# Access Compliance Report

## Public Rights-of-Way

### (Curb Ramps)

Intersection ID: 14035	Main Street: HANOVER_ST	Cross Street: SHENANDOAH_AV	Location:	N
ADA ID: 191767378A26	Ramp Type: Perp	Initial Pass/Fail: Fail	Overall Compliance: No	Severity Score: 33.75
Codes/Mitigation Info/Possible Solution		Field Measurements/Component Compliance

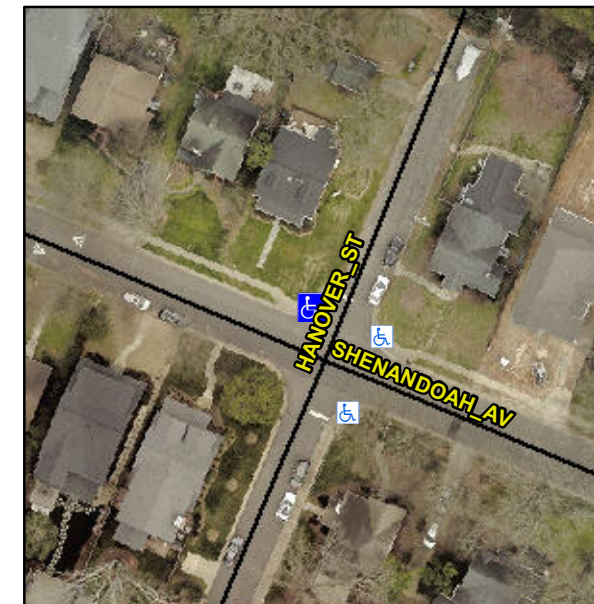
**Not Found, R304.5.1, R304.2.2, R304.5.3**

Compliance	Description	Data	Compliance	Description	Data
N/A	Ramp Length (in)	61.0	No	Ramp Slope (%)	8.5
No	Ramp Width (in)	40.0	No	Ramp XSlope (%)	5.9
N/A	Flare Type LT	N/A	N/A	Flare Type RT	N/A
N/A	Flare Slope LT (%)	N/A	N/A	Flare Slope RT (%)	N/A
N/A	Flare Traversable LT?	N/A	N/A	Flare Traversable RT?	N/A
N/A	Landing Length (in)	N/A	N/A	DWS Provided?	N/A
N/A	Landing Width (in)	N/A	N/A	DWS Contrast?	N/A
N/A	Landing Slope (%)	N/A	N/A	DWS Length (in)	N/A
N/A	Landing X Slope (%)	N/A	N/A	DWS Full Width?	N/A
N/A	Landing Curb? (Y/N)	N/A	N/A	DWS Offset (in)	N/A
N/A	Shared Landing?	N/A			
N/A	Gutter Ponding?	N/A	N/A	Gutter Slope (%)	N/A
N/A	Gutter Lip Ht (in)	0.5	N/A	Gutter X Slope (%)	N/A
N/A	Painted X Walk1?	No	N/A	Painted X Walk2?	N/A
	X Walk 1 Direction	To SE		X Walk 2 Direction	N/A
N/A	X Walk 1 Width (in)	N/A	N/A	X Walk 2 Width (in)	N/A
	X Walk 1 Slope (%)	0.7		X Walk 2 Slope (%)	N/A
	X Walk 1 X Slope (%)	5.5		X Walk 2 X Slope (%)	N/A

**Remove & Replace Entire Ramp.**
